Connect the Coastside comments re **Moss Beach**  
From Lisa Ketcham, 6/21/20

#### **CARLOS ST. COMMERCIAL DISTRICT**

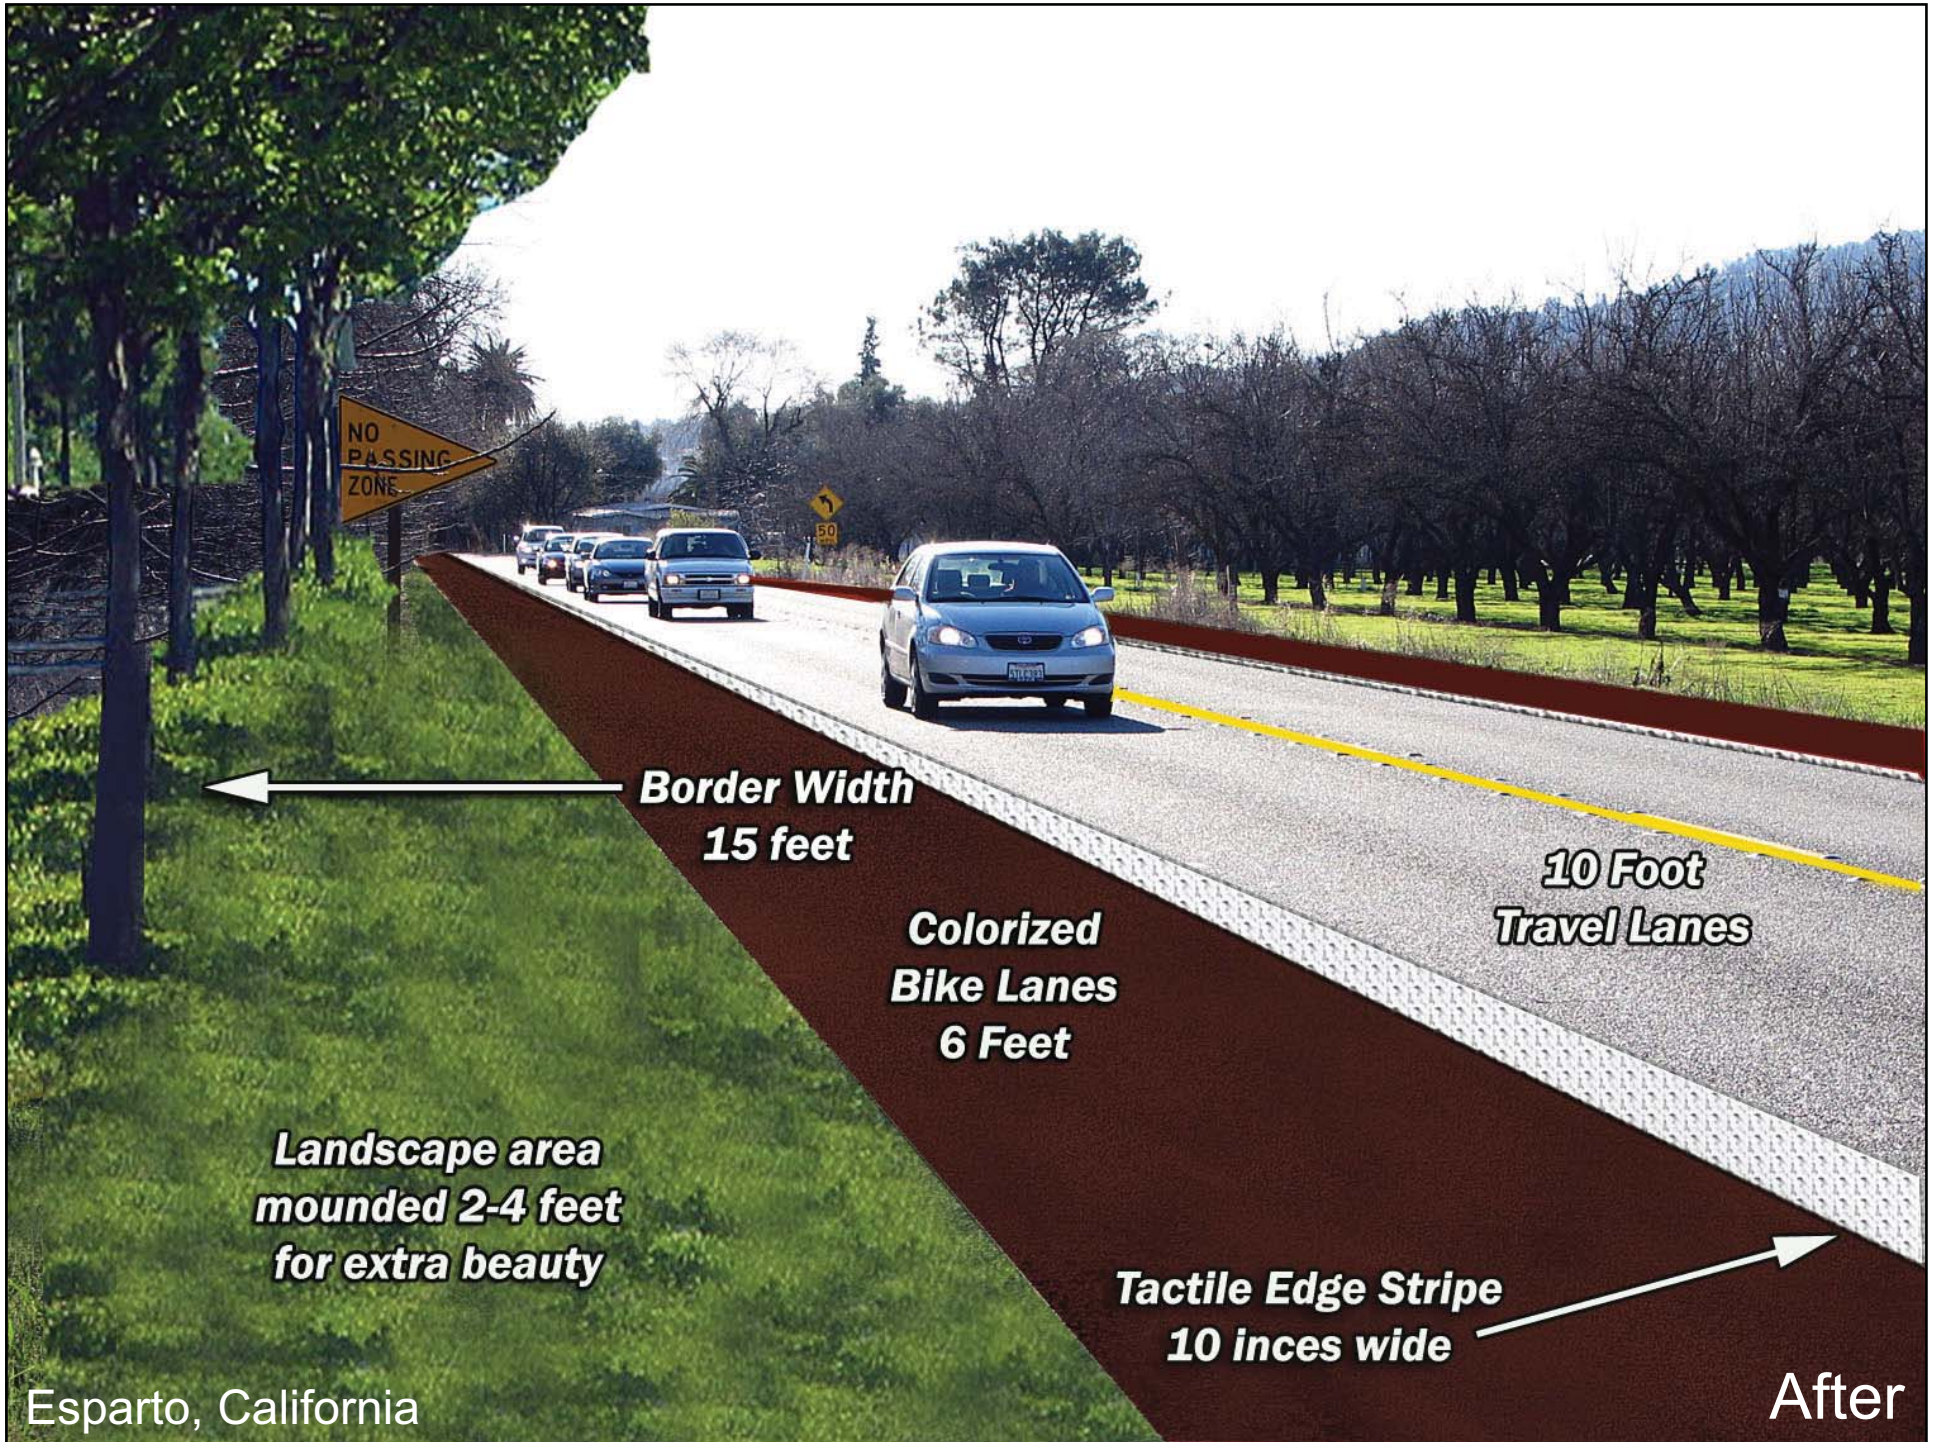
East side Hwy 1 unpaved shoulder across Montara Creek ravine, 14-16<sup>th</sup> St, is critical trail connection between Montara and Moss Beach.

After 2012 highway widening for center turn lane, a citizen tree pruning effort regained lost trail space:

Level ground for trail regained by pruning encroaching branches. A string trimmer could mow the rest of the vegetation. Trail surface DG could be replenished. Additional safety could be provided by installing a guard rail at pavement edge.
